Land in Churchfield Lane, Kexborough, Barnsley

A pre-application enquiry was submitted, 10 March 2014, the response was received, 23 April 2014.

Response, 23 April 2014, from LPA's Planning Officer:

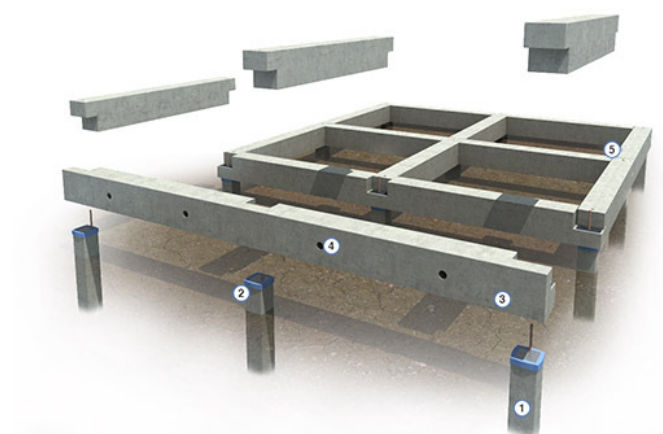
I have some serious reservations about this scheme. In principle it could actually prove possible to construct the dwellings shown with the use of specialist construction techniques and still retain the trees, however the resulting properties would be heavily overshadowed by the trees and there is the potential for future conflicts with the residents. I personally feel that the proximity of the dwellings to the trees is too close and would lead to future pressure on them to be removed or severely pruned, but as stated previously this doesn't mean that physically it couldn't be done. Given the significance of the issues then any construction is likely to be very costly as nearly all the buildings to be constructed implicate the trees. I would suggest that the pros and cons of this layout be looked at to try and ease the potential issues between the trees and the buildings and the trees and future residents if it is decided to pursue the development of this site.

If this application were to be pursued then we would require all the arboricultural and engineering information up front for consideration as it would be inappropriate to grant permission and ask for it at a later date given the obvious issues. In addition to a full tree survey to BS5837:2012 a detailed arboricultural method statement would be required and would need to incorporate all the specific engineering details of the methodologies to be used to clearly demonstrate that the construction could be carried out in a way which would not damage the trees.

As the proposal stands at the minute I would be minded to recommend it be refused on arboricultural grounds unless a very good case could be put forward as to why it is feasible and how any potential future conflicts both during construction and afterwards could be managed to prevent both short and long term damage/threats to the trees.

The construction techniques of buildings within close proximity of trees are well established and not necessarily expensive e.g. the Charcon Fast Beam system:

and future management of the trees on the site is achievable without the need for drastic felling measures, which is acknowledged by the tree officer.

Comment is made about the proposed dwellings being overshadowed by the existing trees and whilst they may well create a darkening of the sky, it should be noted that the trees are mainly located along the northern and eastern boundaries.
